# BARBARICK RECYCLING AND REFUSE TRANSFER STATION

CONSTRUCTION DOCUMENTS  
MARCH 2024

BARBARICK WASTE TRANSFER STATION  
EL PASO COUNTY, COLORADO  
CONSTRUCTION DOCUMENTS  
COVER SHEET

BARBARICK WASTE TRANSFER STATION  
 EL PASO COUNTY, COLORADO  
 DRAINAGE MAP  
 PROPOSED CONDITIONS

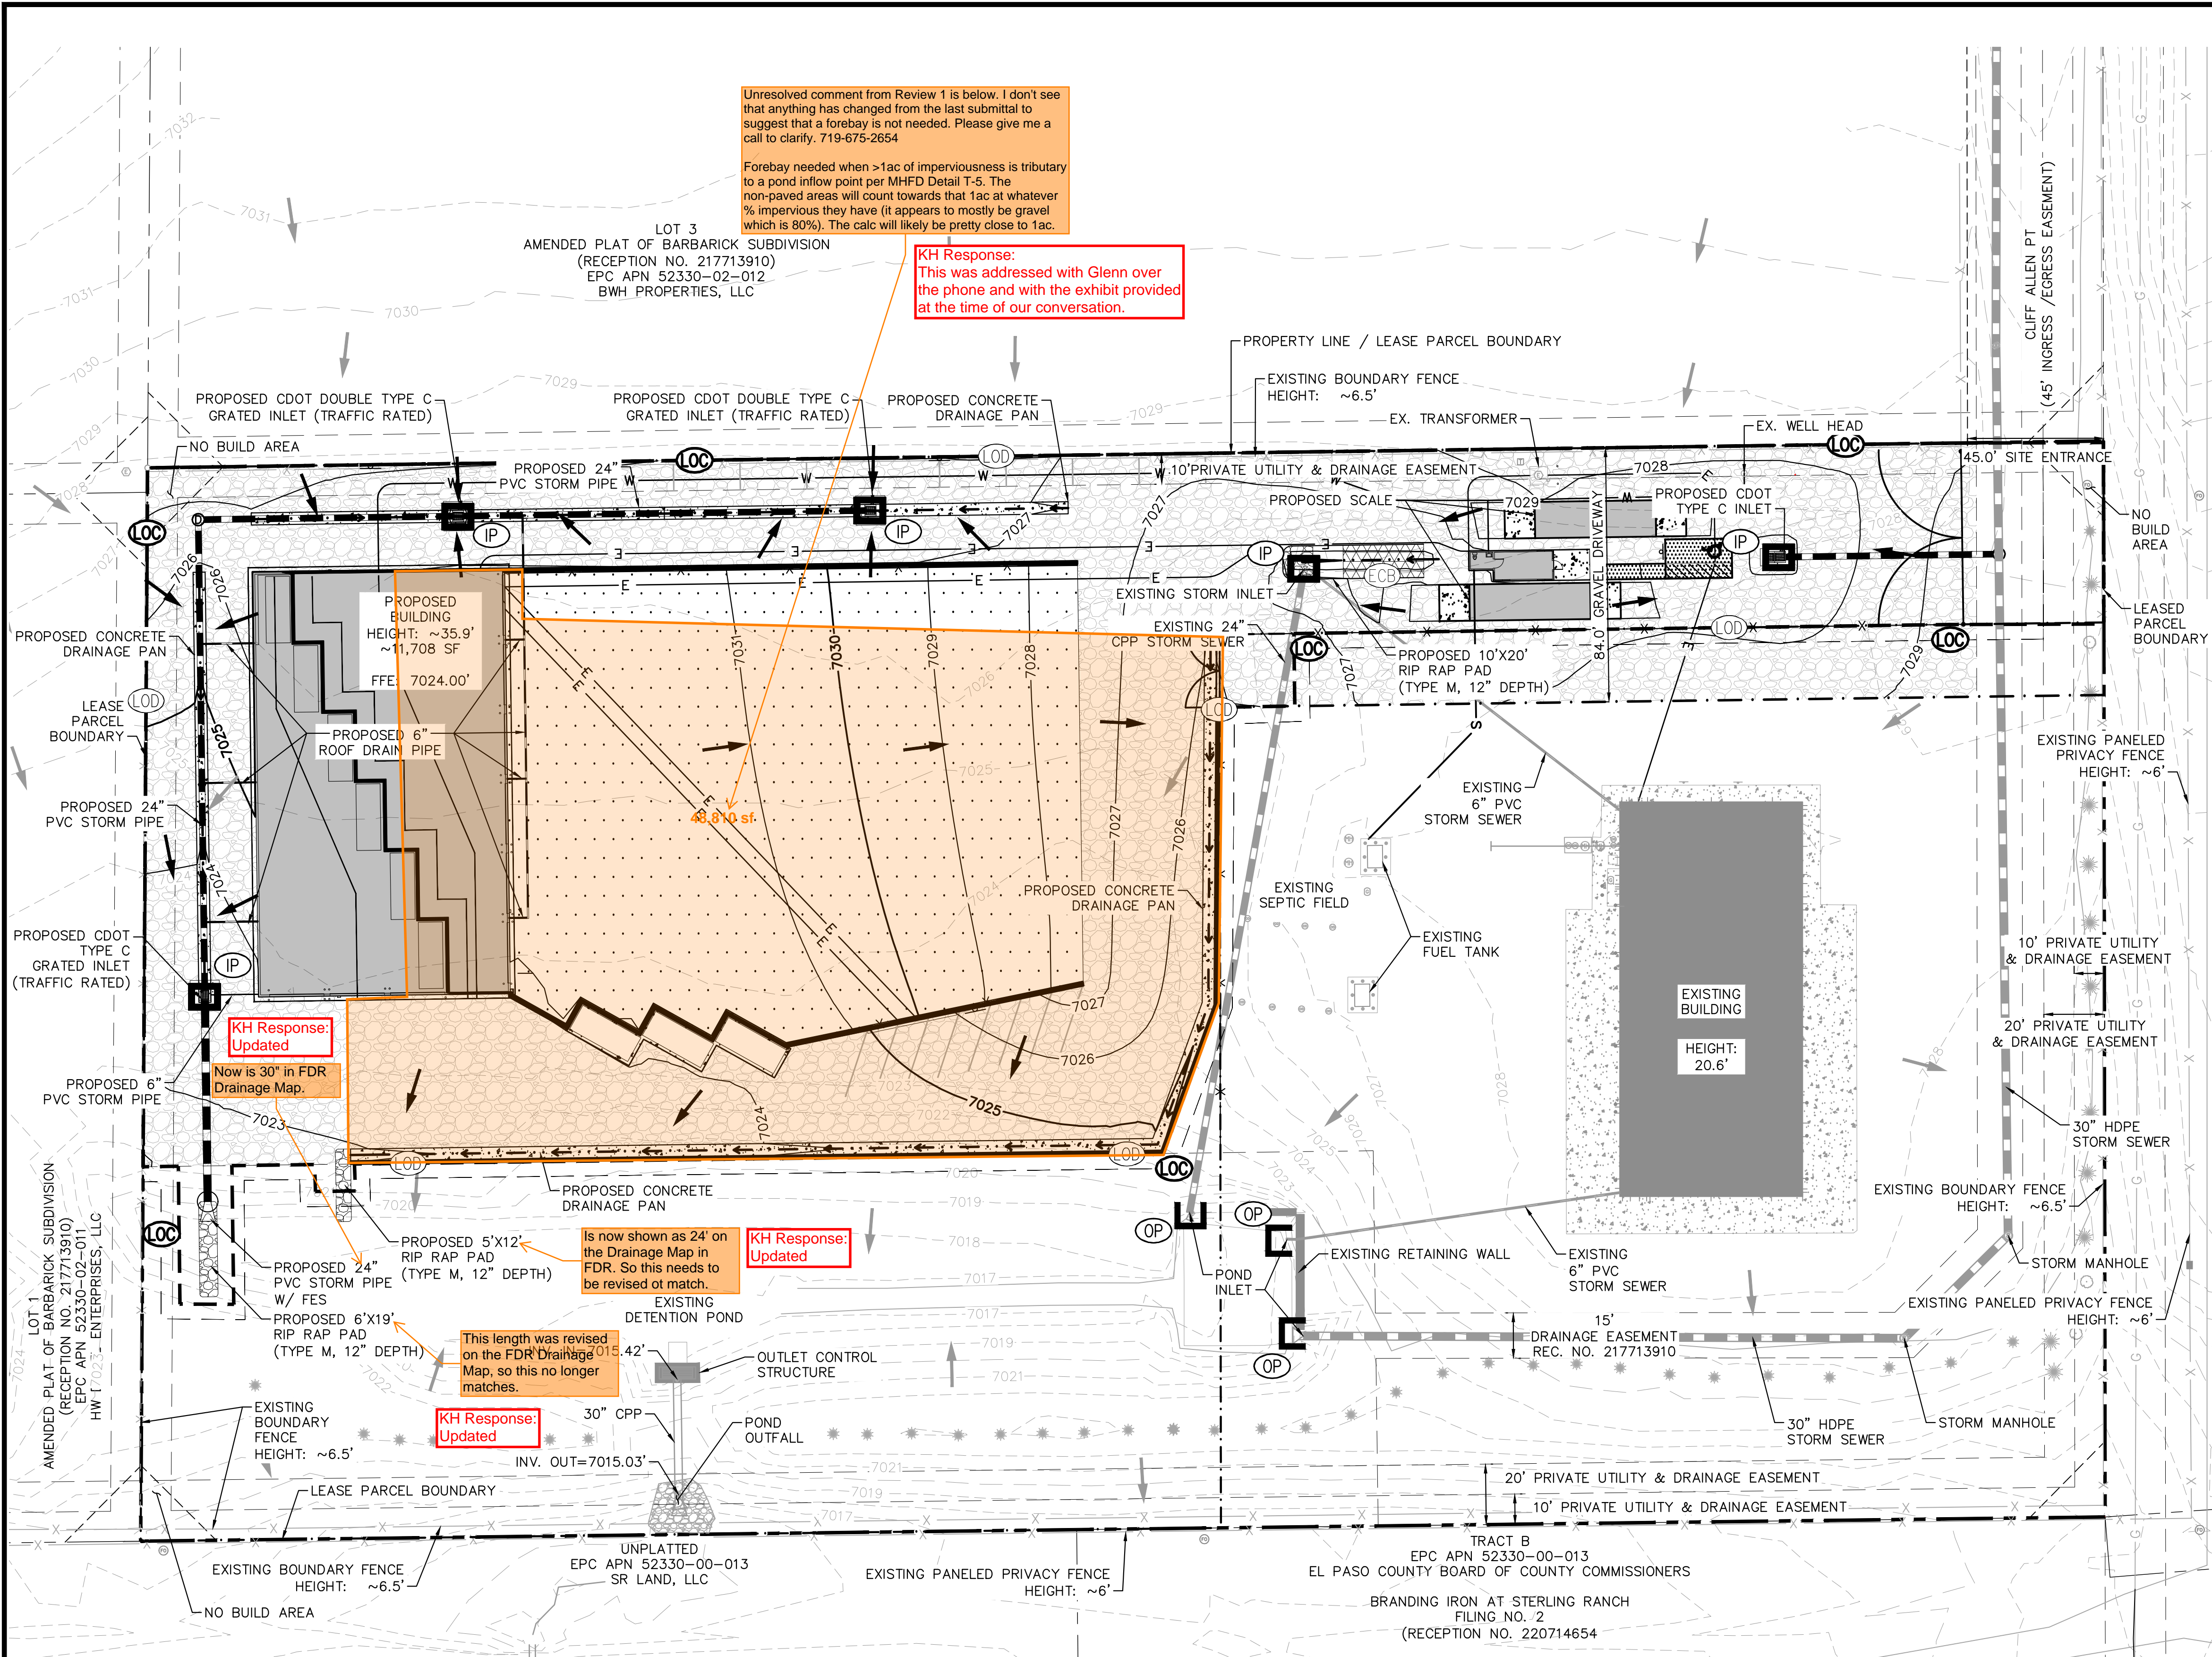
Forebay needed when >1ac of imperviousness is tributary to a pond inflow point per MHFD Detail T-5. The non-paved areas will count towards that 1ac at whatever % impervious they have (it appears to mostly be gravel which is 80%). The calc will likely be pretty close to 1ac.

PROJECT NO.  
196489000  
SHEET  
L7.0

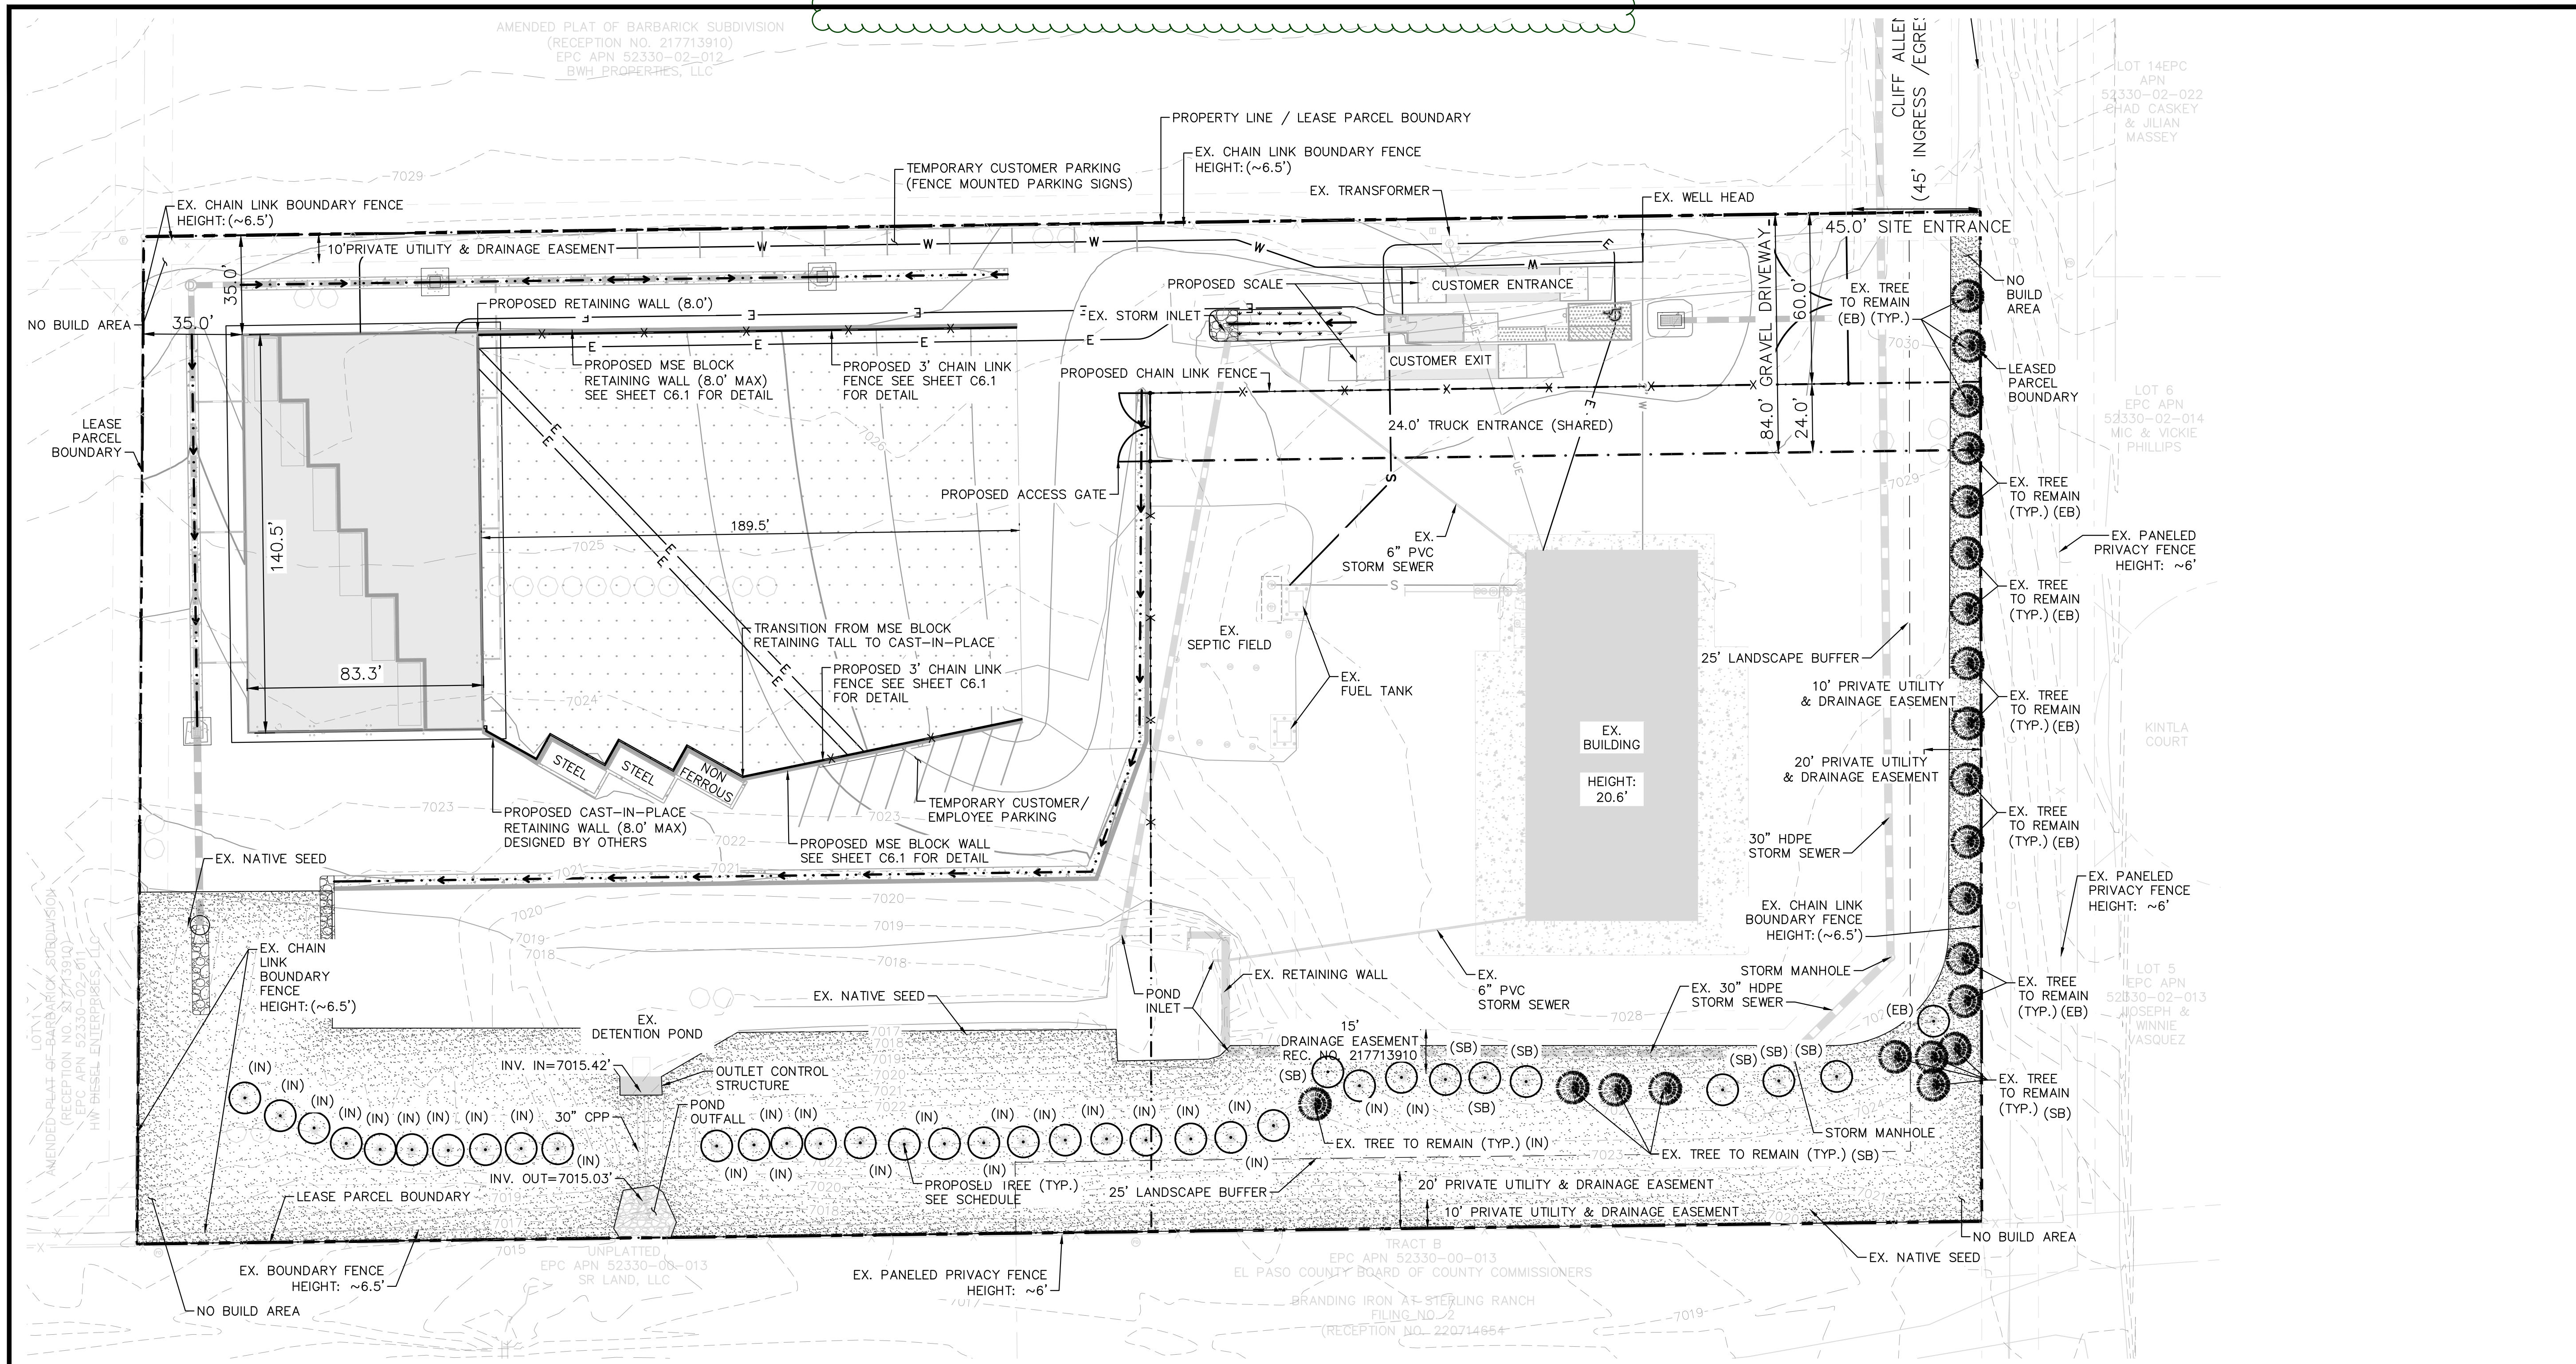
Please title as alternative landscape plan and explain in the LOI the justification for why you cant meet landscape code

KH Response:  
Addressed, left as is per conversation with Ashlyn and Aaron.
